**TOPOGRAPHIC MAP**  
**LOT 1D NORTH, THE 480 RANCH SUBDIVISION**  
 LOCATED IN SECTION 12, T6N, R87W, 6TH P.M.,  
 COUNTY OF ROUTT, STATE OF COLORADO

TURCOTTE  
RESIDENCE

TURCOTTE RESIDENCE

JOB NO: 16-067  
DRAWN: BAB  
DATE: 09-10-16

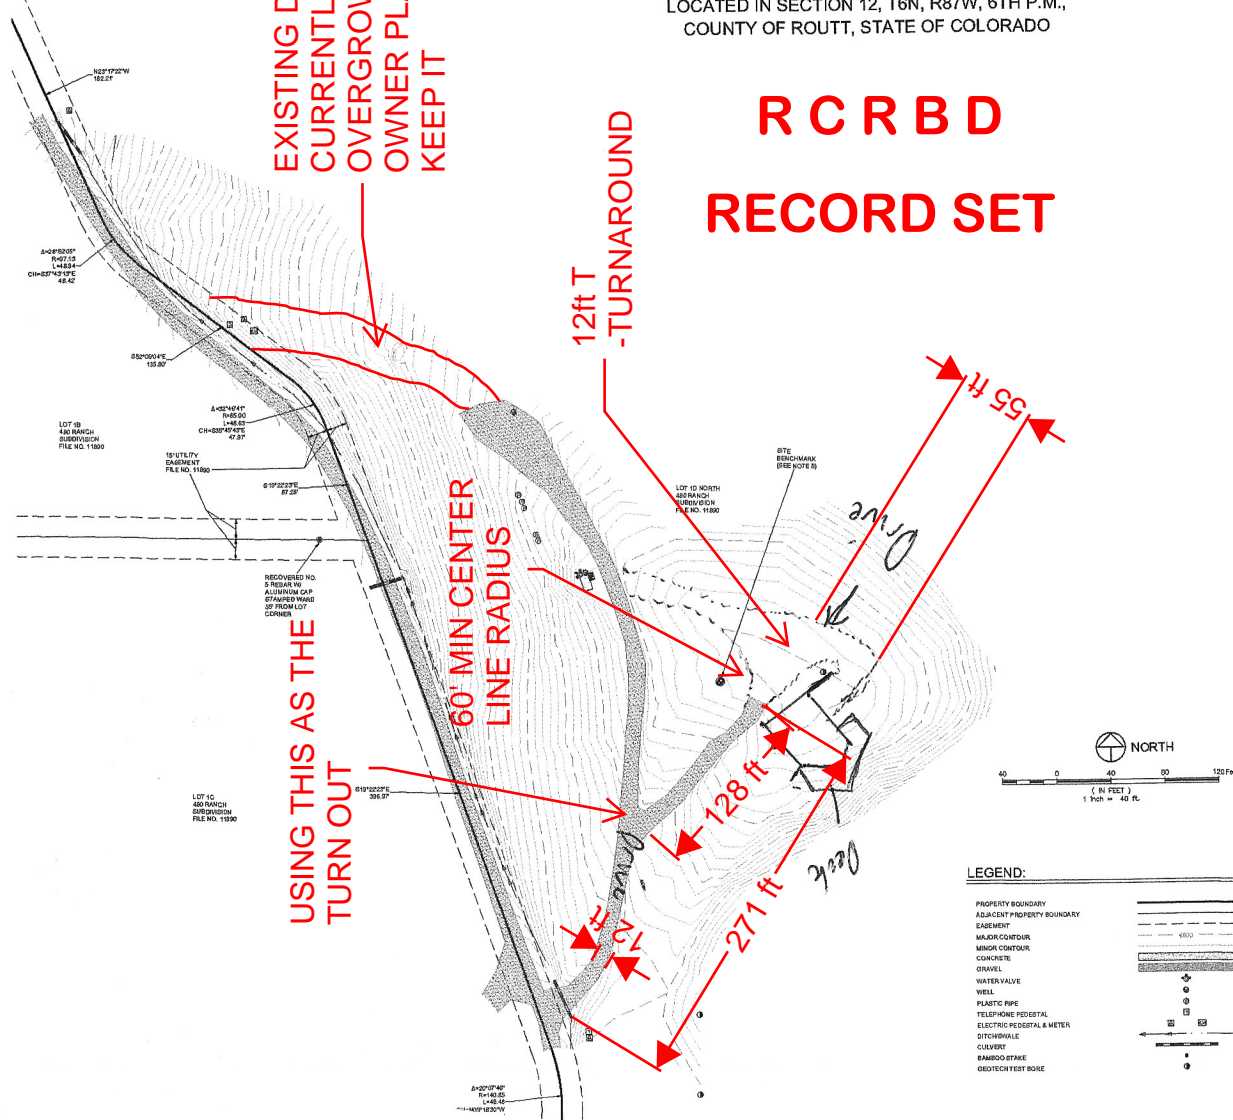
EXISTING DRIVE,  
 CURRENTLY  
 OVERGROWN BUT  
 OWNER PLANS TO  
 KEEP IT

12ft T  
 -TURNAROUND

60' MIN CENTER  
 LINE RADIUS

USING THIS AS THE  
 TURN OUT

TYP WALL SECTION  
SCALE 1/2" = 1'-0"

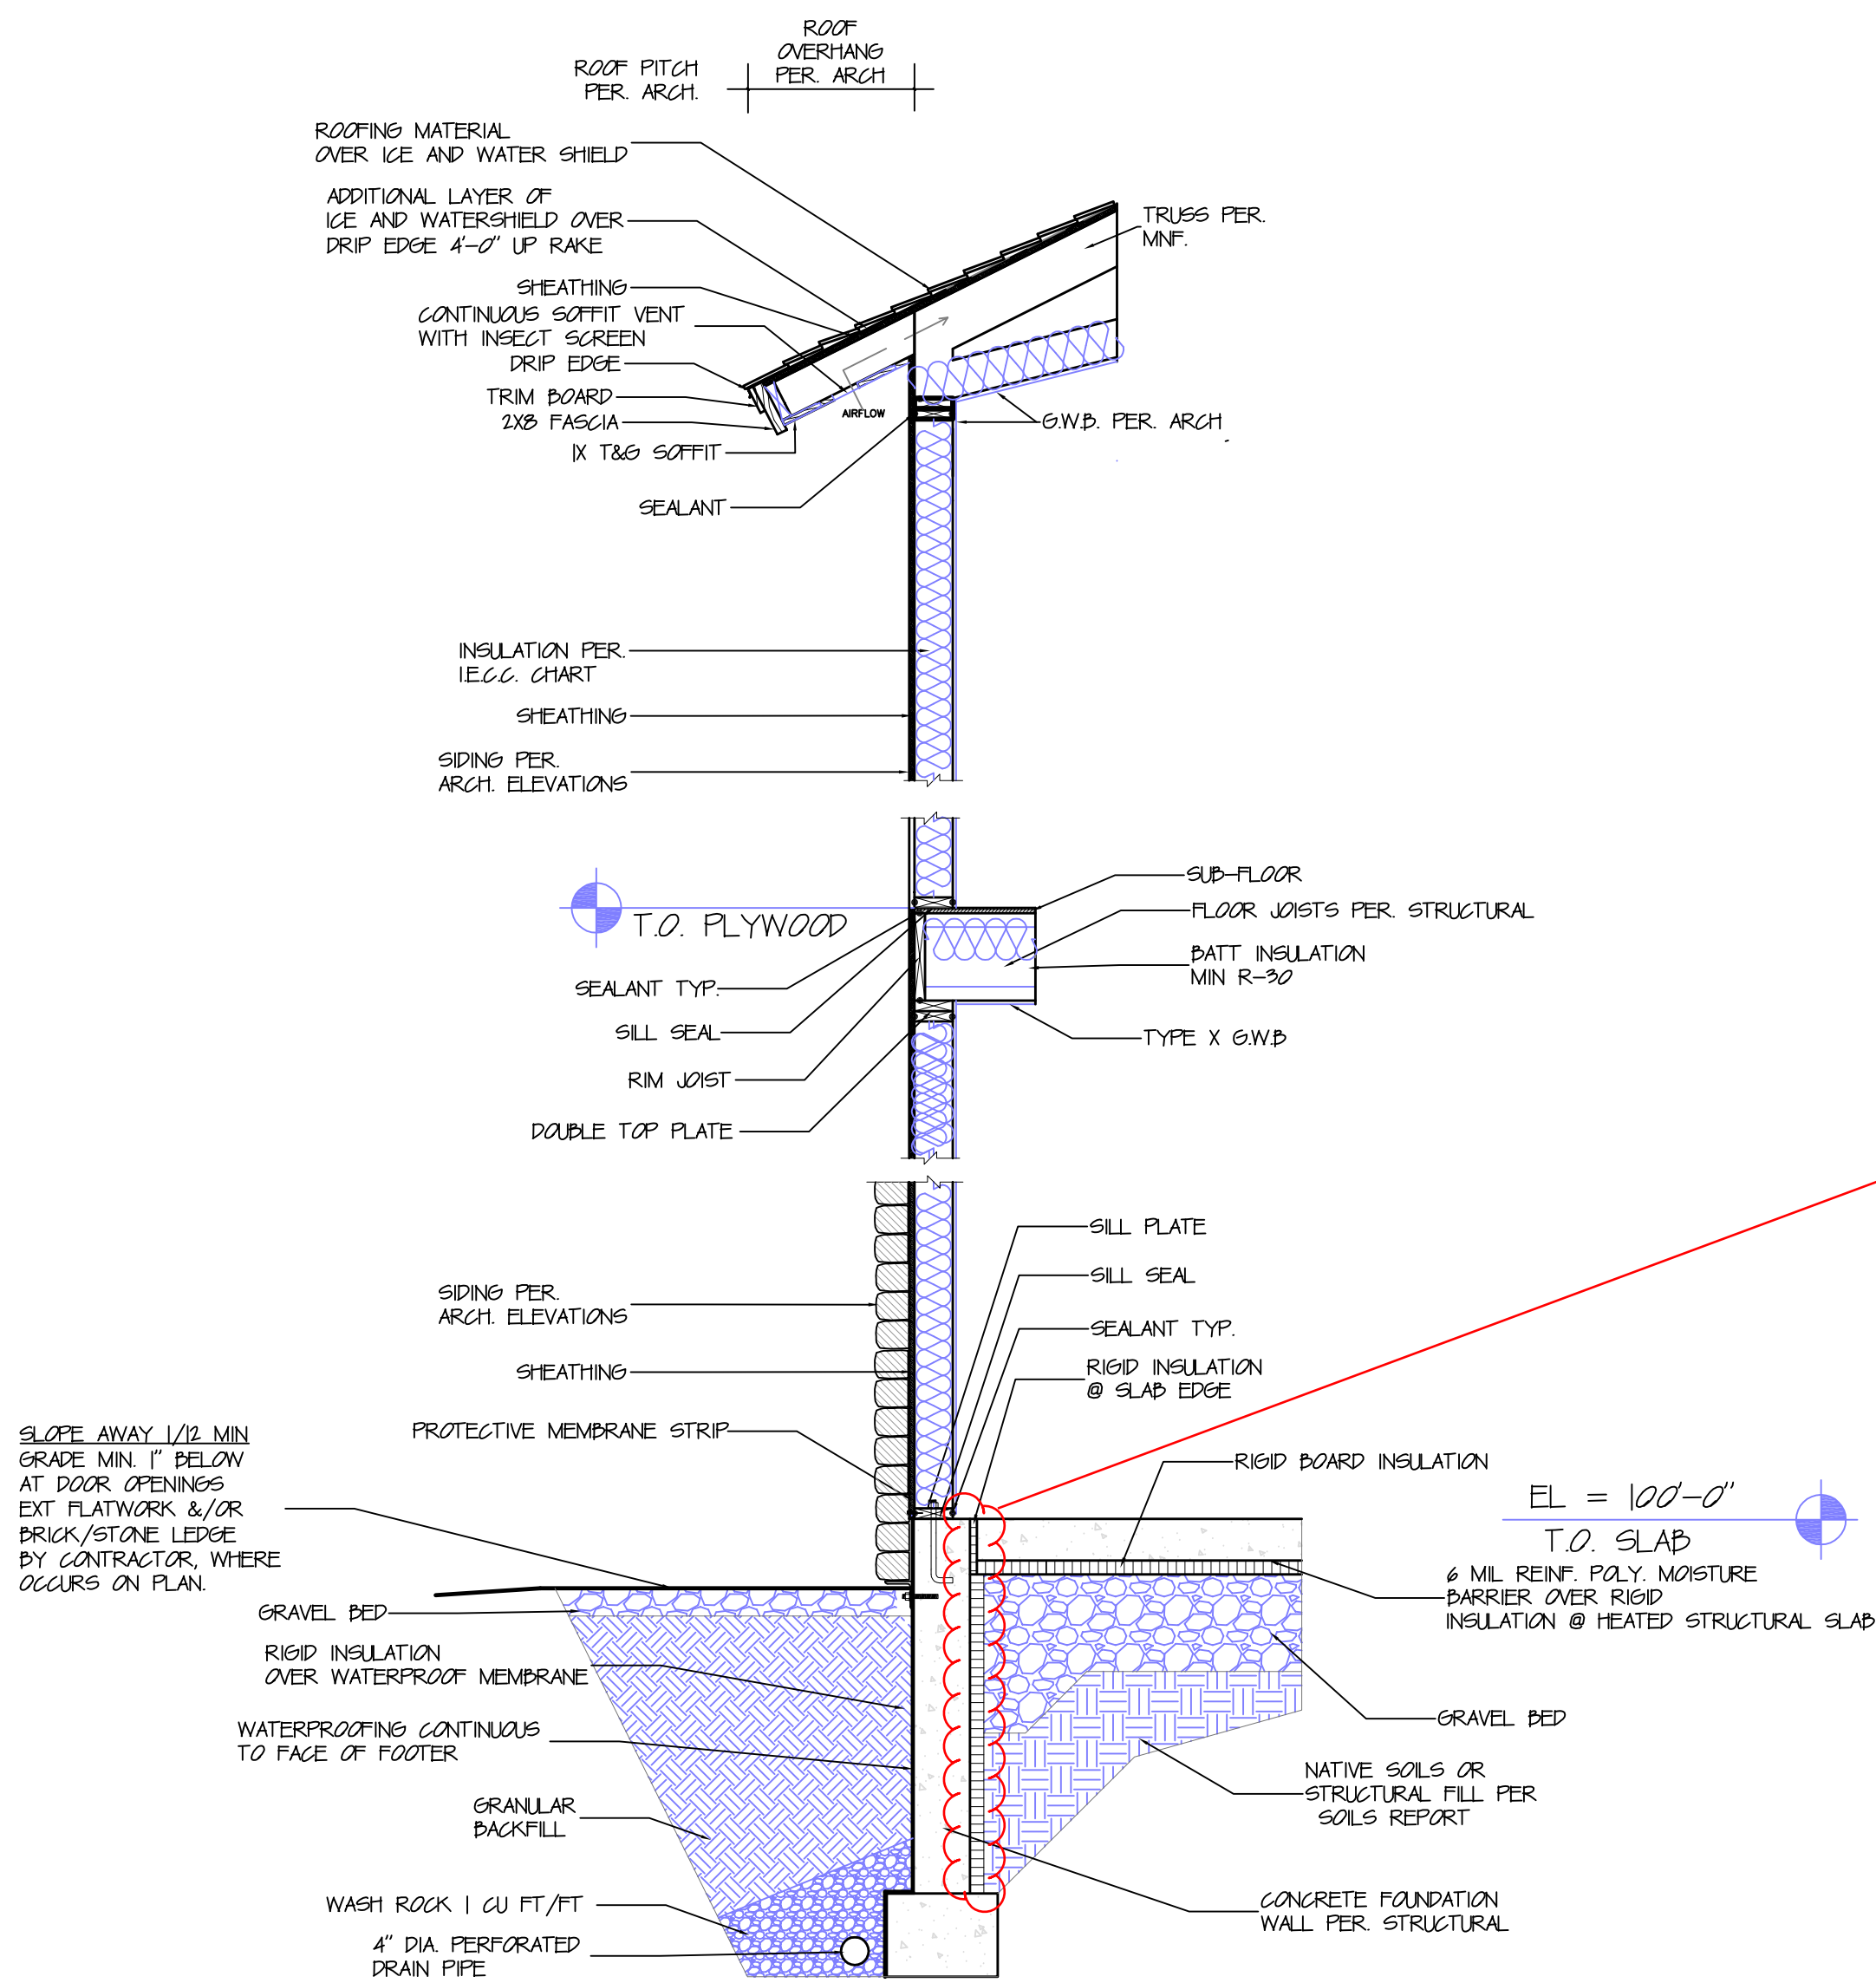
Specify insulation requirements for slabs. These requirements apply only to slabs 12 inches (305 mm) or less below grade. The listed R-value requirements in the table are for unheated slabs. A heated slab must add another R-5 to the required insulation levels based on Note d of Table 402.1.1. Accordingly, a heated slab shall also have insulating materials having a minimum R-value of 5 installed in accordance with Section M2103.2 of the 2009 IRC plus another R-5 for the slab edge component as applicable. The insulation must extend downward from the top of the slab or downward to the bottom of the slab and then horizontally in either direction until the distance listed in Table 402.1.1 is reached. Correct the building sections to reflect this requirement along with any additional requirements for insulation of heated slabs, if applicable.
